**Field Modification Form**  
**Lower Passaic River Restoration Project**  
**Remedial Investigation**  
**Project No: 60145884**

<b>Field Modification Number: FM-120830-1</b>															
<b>Document (plan or SOP title and date)</b> <i>Quality Assurance Project Plan for Lower Passaic River Restoration Project: Periodic Bathymetric Surveys, Rev. 2, May 2010</i>															
<b>Activity:</b> Performing Single Beam Bathymetric Surveys in Shallow Areas Located Outside the Limits of the Multi Beam Bathymetric Surveys in the Lower 14 Miles of the Passaic River															
<p><b>Proposed Modification:</b> The Periodic Bathymetric Surveys Quality Assurance Project Plan (QAPP) (AECOM, 2010) is modified by this Field Modification Form to include performance of single beam bathymetric surveys in shallow areas located outside the limits of the multi beam surveys in selected areas in the lower 14 miles of the Passaic River. Multi beam surveys are limited to areas with water depths greater than approximately 6 feet (measured as water depth not NGVD), due to beam limitations and risk of damage to the multi beam transducer head. Single beam surveys will fill in areas between approximately

Figure 2: Survey Areas of Single Beam Surveys

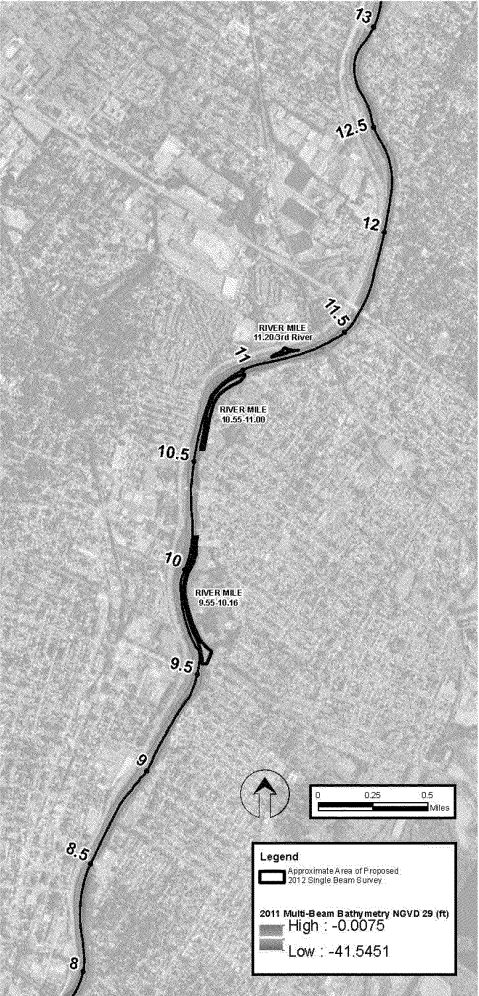
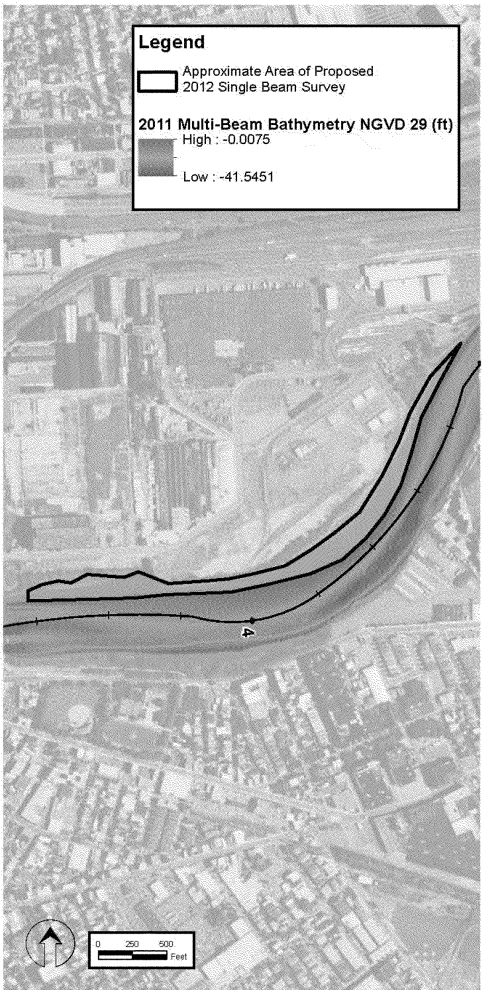
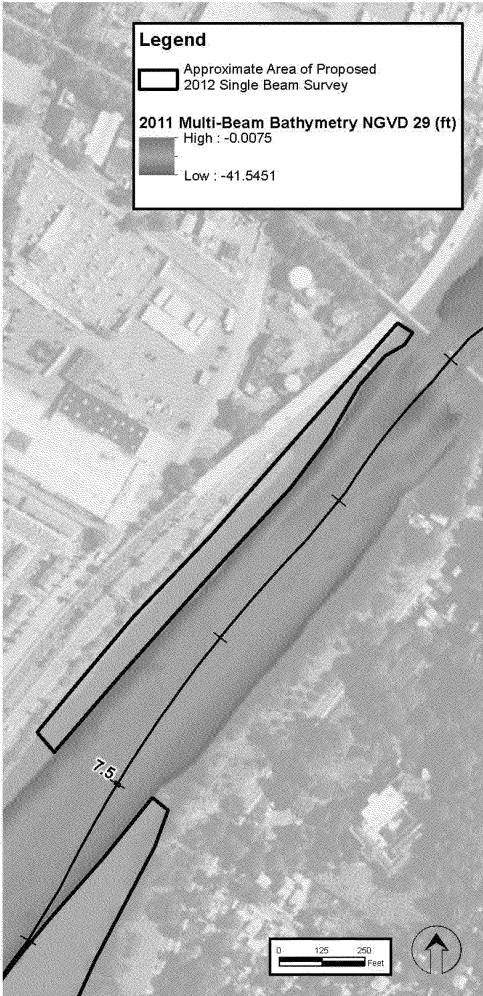
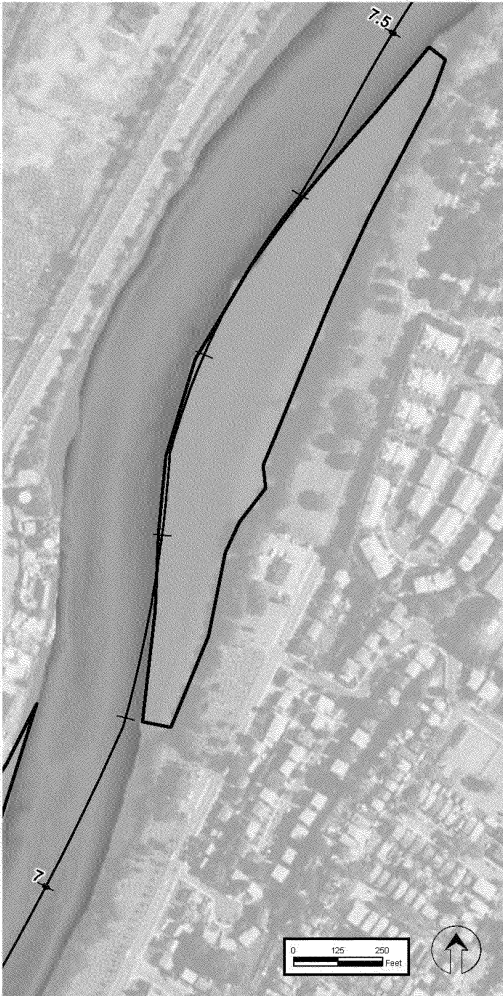
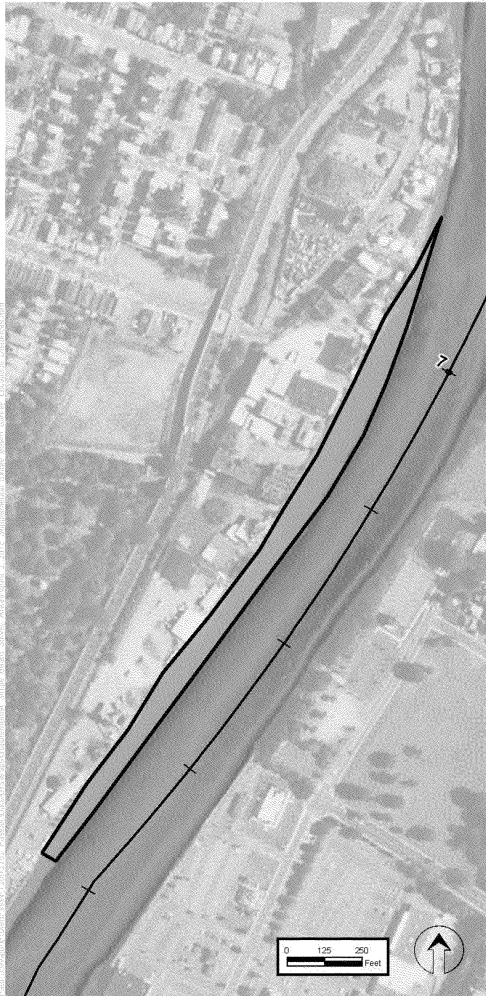
<table><tr> <th>Single Beam Survey Area</th><th>Date of CPG Single Beam Survey, if previously performed</th></tr><tr> <td>RM 0.00 - 0.88</td><td>2007 – 100 ft. spacing – Northern portion of the survey area</td></tr><tr> <td>RM 1.80 - 3.05</td><td>2007 – 100 ft. spacing</td></tr><tr> <td>RM 3.50 - 4.32</td><td>2007 – 100 ft. spacing</td></tr><tr> <td>RM 6.60 - 7.10</td><td>2007 – 100 ft. spacing</td></tr><tr> <td>RM 7.10 - 7.50</td><td>2007 – 100 ft. spacing</td></tr><tr> <td>RM 7.50 - 7.80</td><td>2007 – 100 ft. spacing</td></tr></table>

Single Beam Survey Area	
RM 9.55 - 10.16	None
RM 10.55 – 11.00	2011 RM 10.9 Survey – 50 ft. spacing
RM11.20 and Third River	2011 RM 10.9 Survey – 50 ft. spacing
